Project	The Falls on Refugee Road	Addendum Number	3
Project Number	23446	Date	07/10/2025
To	All Bidders

This addendum contains changes to the requirements of the bidding Documents, Project Manual and Construction Drawings which have been issued to date. Such changes are to be incorporated into the Construction Documents and shall apply to the work in the same meaning and force as if they had been included in the original documents. Wherever this Addendum modifies a portion of a paragraph of the Project Manual or a portion of any Drawing, the remainder of the paragraph or Drawing shall remain in force.

C105

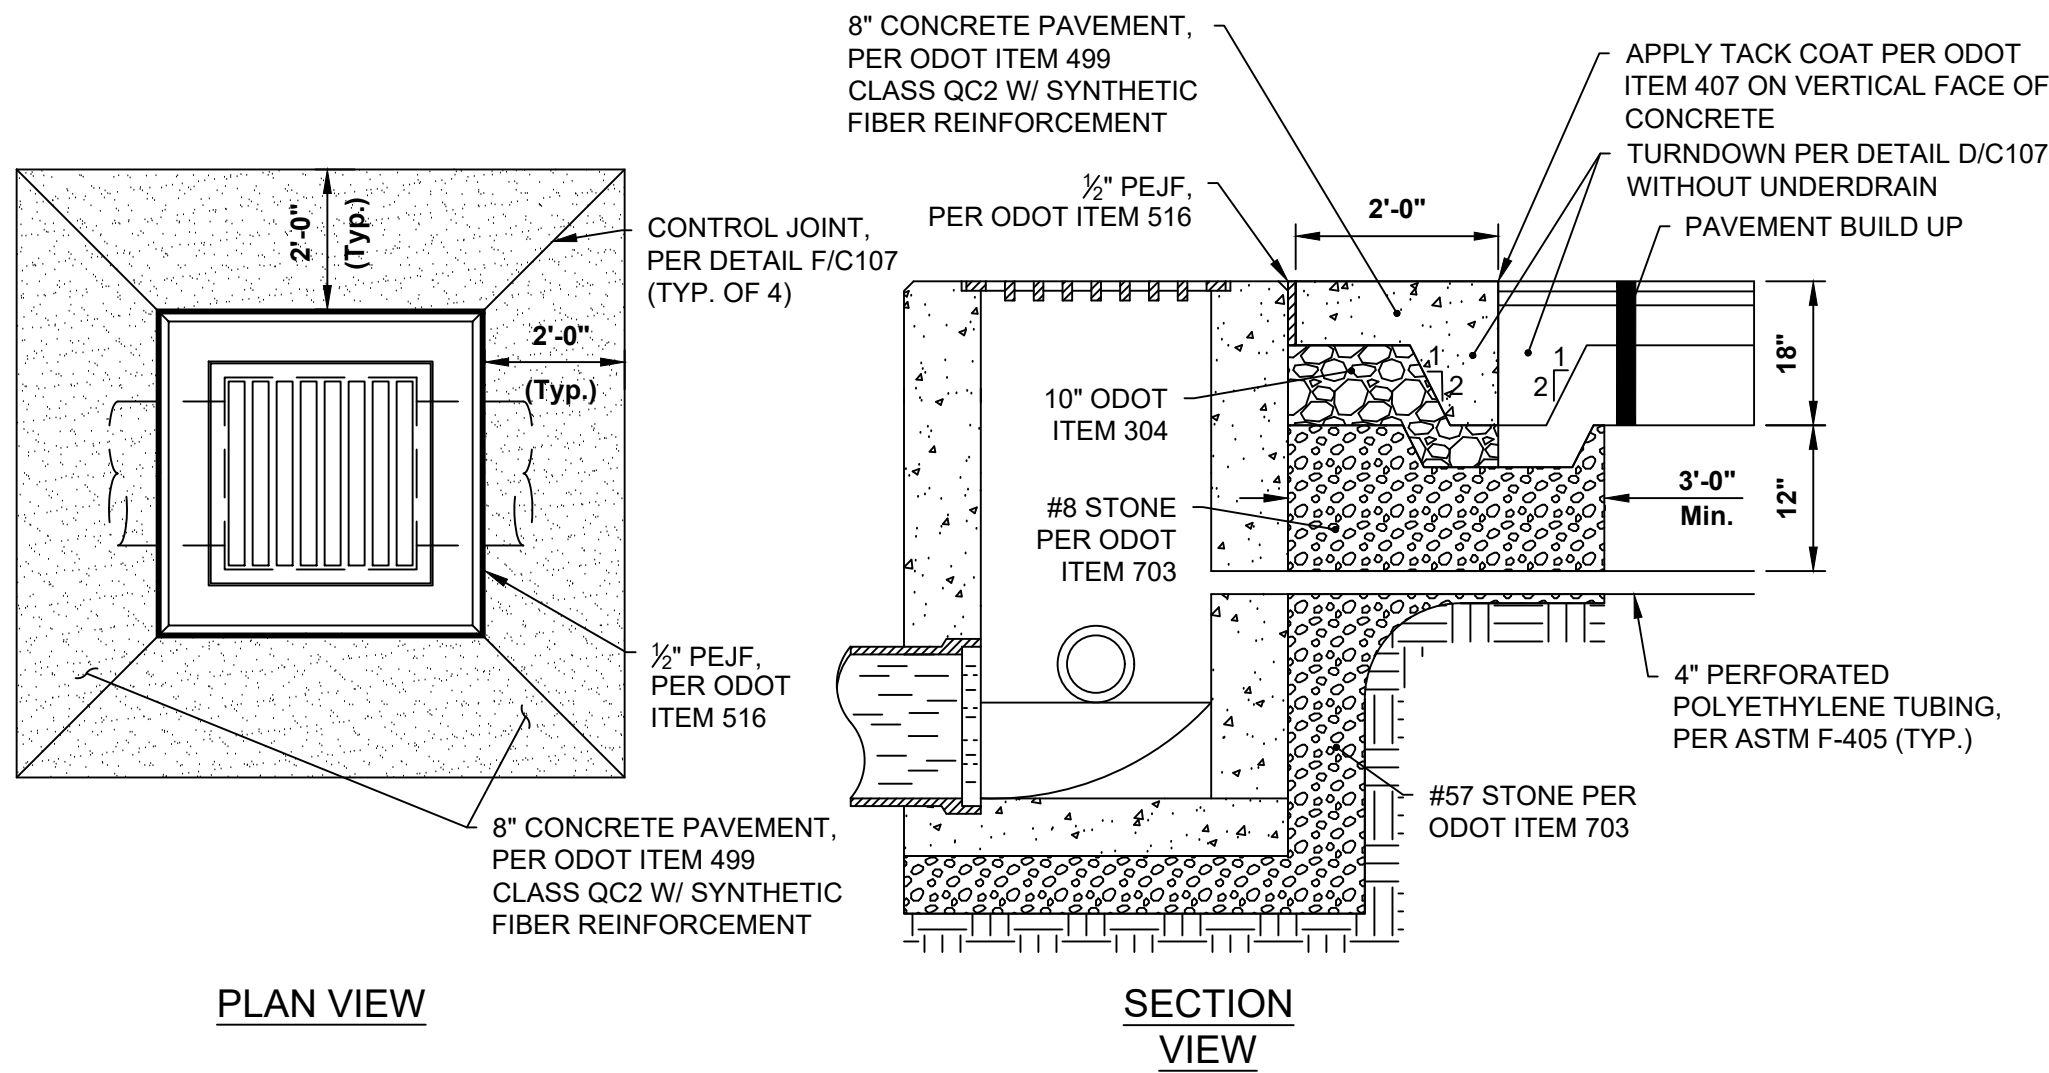
5. SHEET C105 – STAKING PLAN

- A. **ADD** bulk enclosures.
- B. **REVISE** proposed AC unit locations.
- C. **REVISE** proposed tree locations.
- D. **ADD** bollard to legend.
- E. **ADD** coded notes 2,3,4.

05/01/2025
	23446
	C208
	CD PROGRESS SET

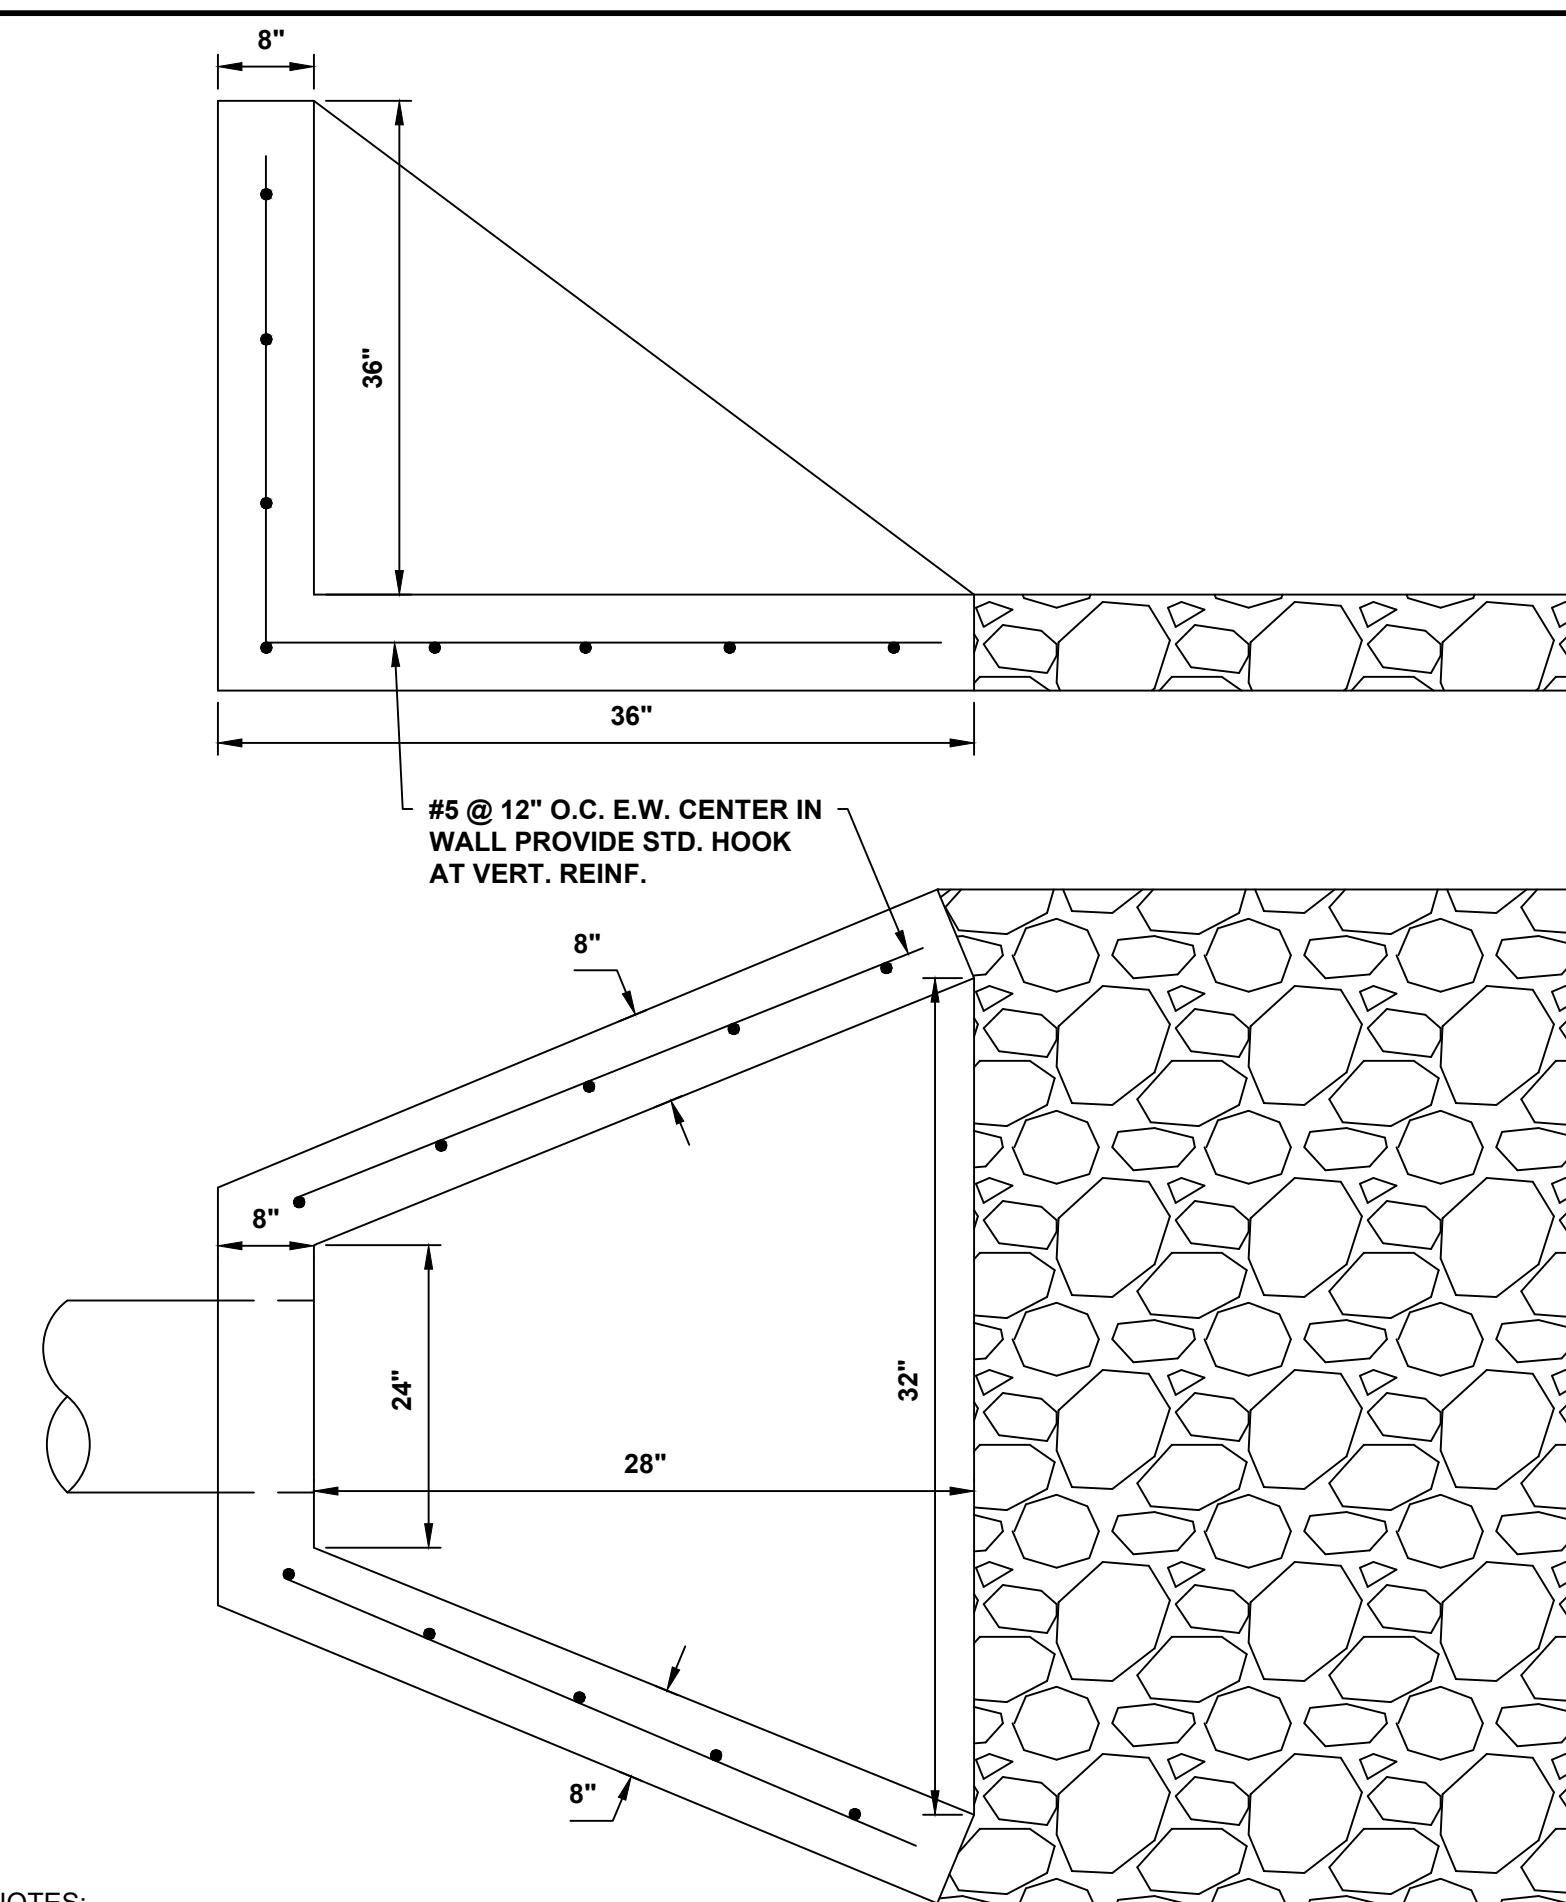
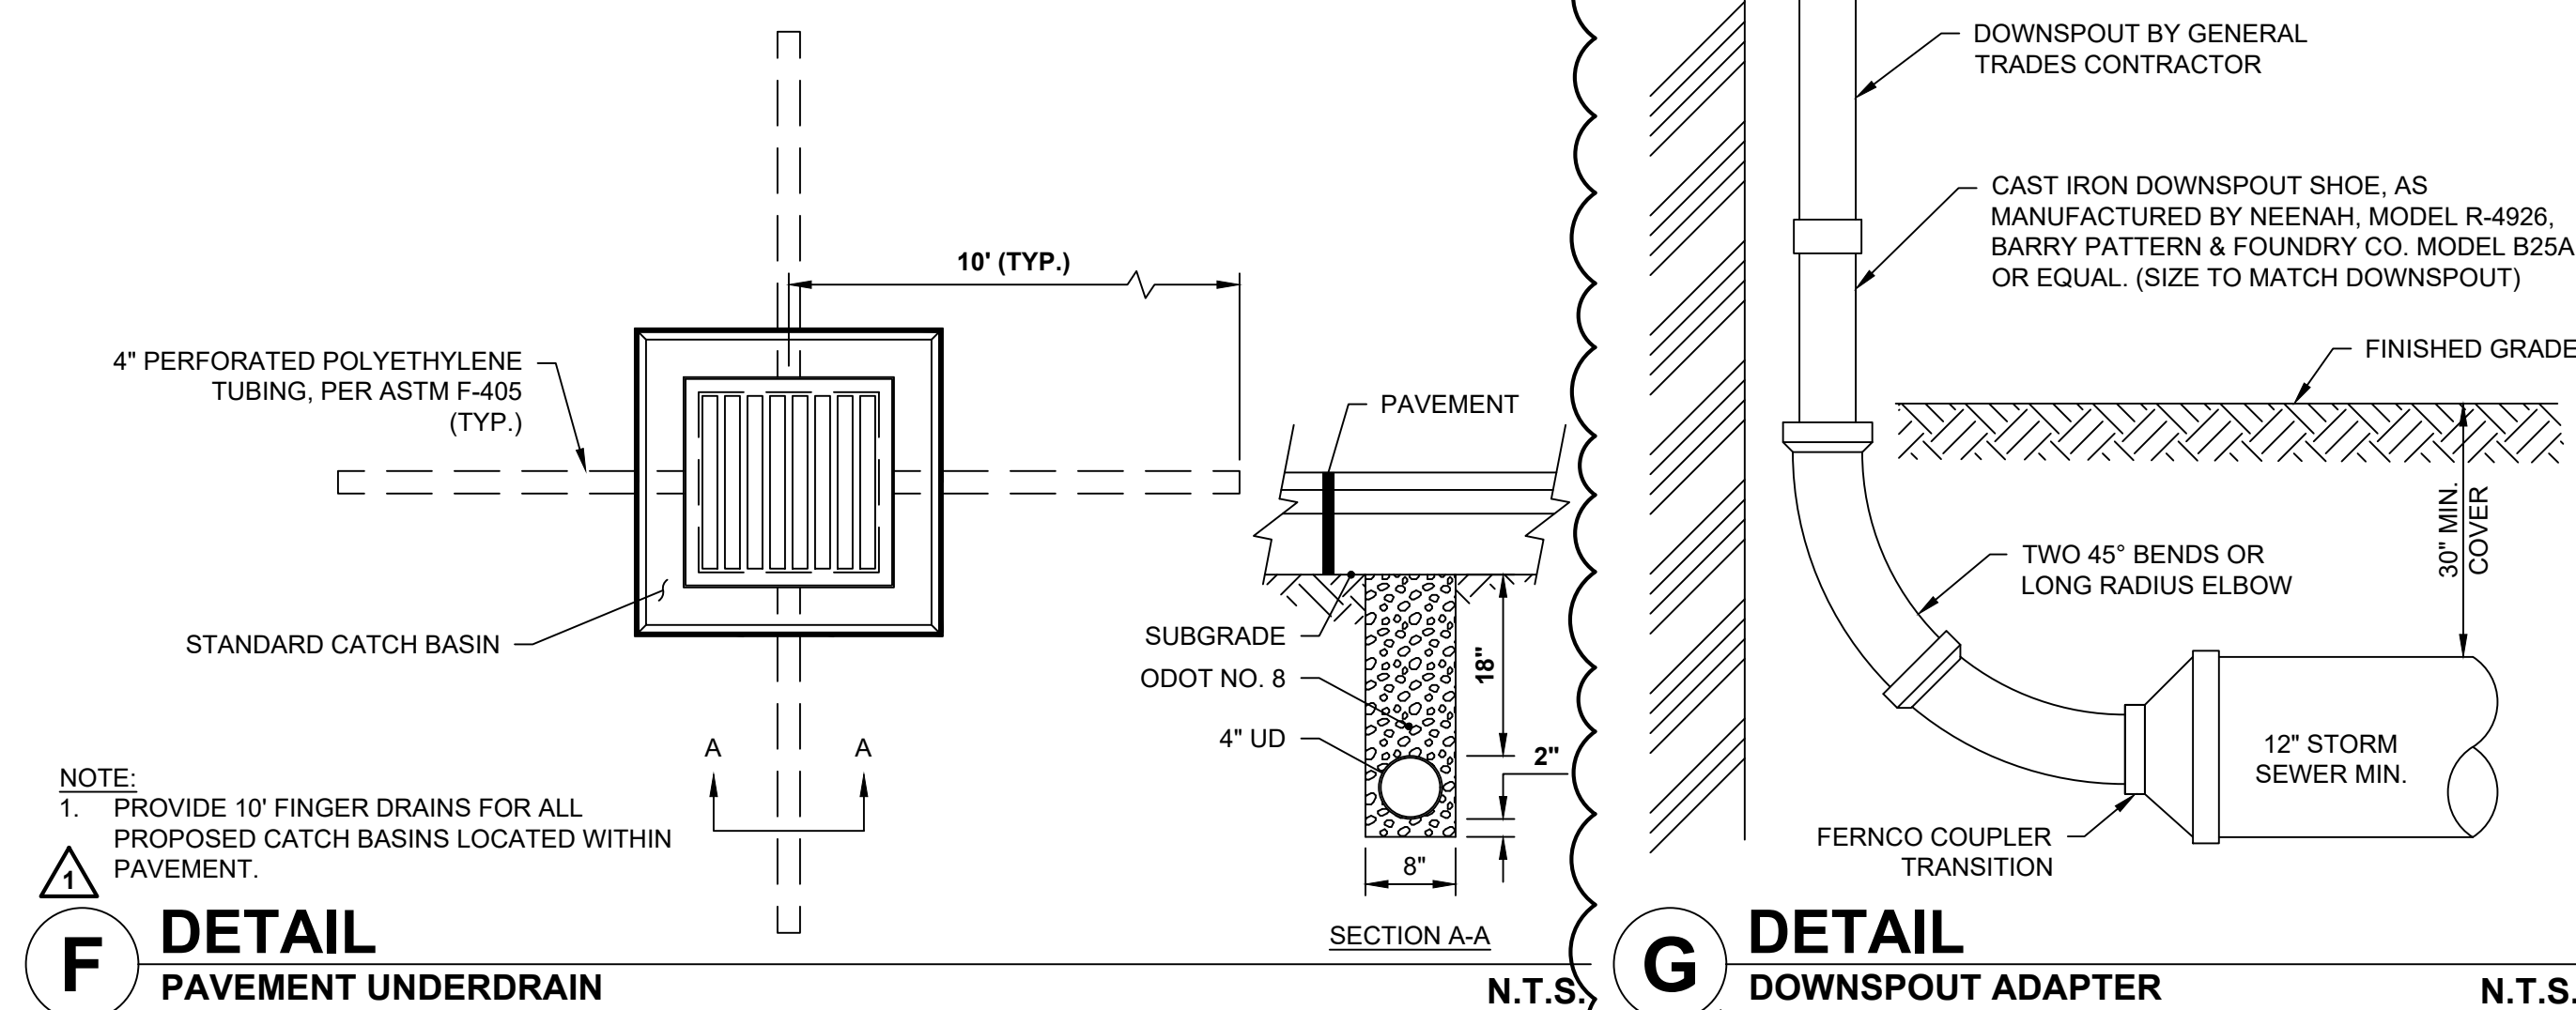
9. SHEET C208 – STORM SEWER & GRADING PLAN
 - A. **ADD** bulk enclosures.
 - B. **ADD** coded notes 4.
 - A. **ADD** downspouts and roof drains with associated cleanouts.
